**CITY OF KELOWNA**  
**MEMORANDUM**

**Date:** January 14, 2016  
**File No.:** Z15-0066

**Subject:** 3697 Lakeshore Road

RU1 to RU6

**SUBDIVISION PLAN OF LOT 24 BLOCK 4 D.L. 134  
O.D.Y.D. PLAN 515 EXCEPT PLAN KAP91276**

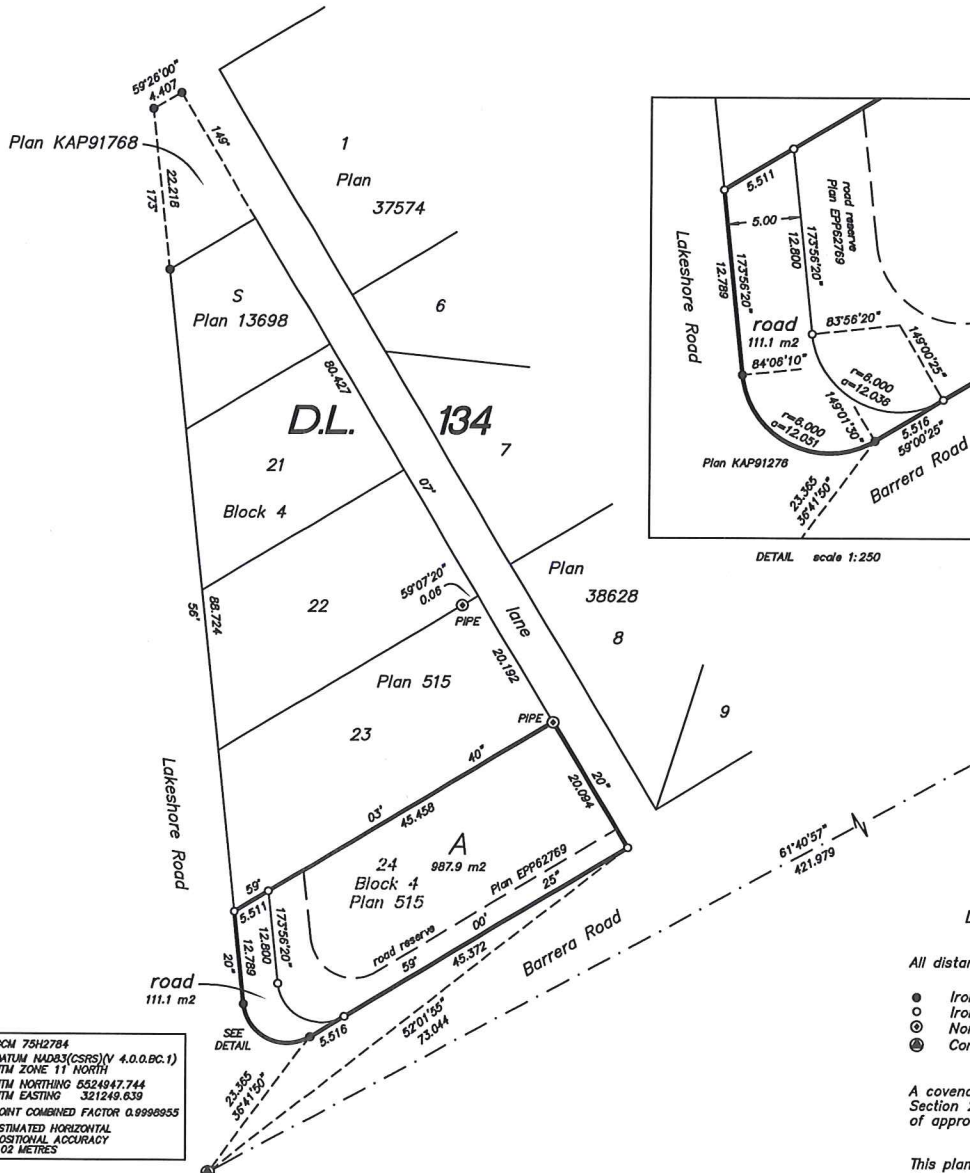
- (a) Grant Statutory Rights Of Way if required for utility services.
- (b) Provide a 5.0m dedication and a 5.0m road reserve along the full frontage of Lakeshore Rd.
- (c) Provide ~3.0m road reserve along the full frontage of Barrera road to match property lines to the east.
- (d) If any road dedication or closure affects lands encumbered by a Utility right-of-way (such as Hydro, Telus, Gas, etc.) please obtain the approval of the utility. Any works required by the utility as a consequence of the road dedication or closure must be incorporated in the construction drawings submitted to the City's Development Manager.
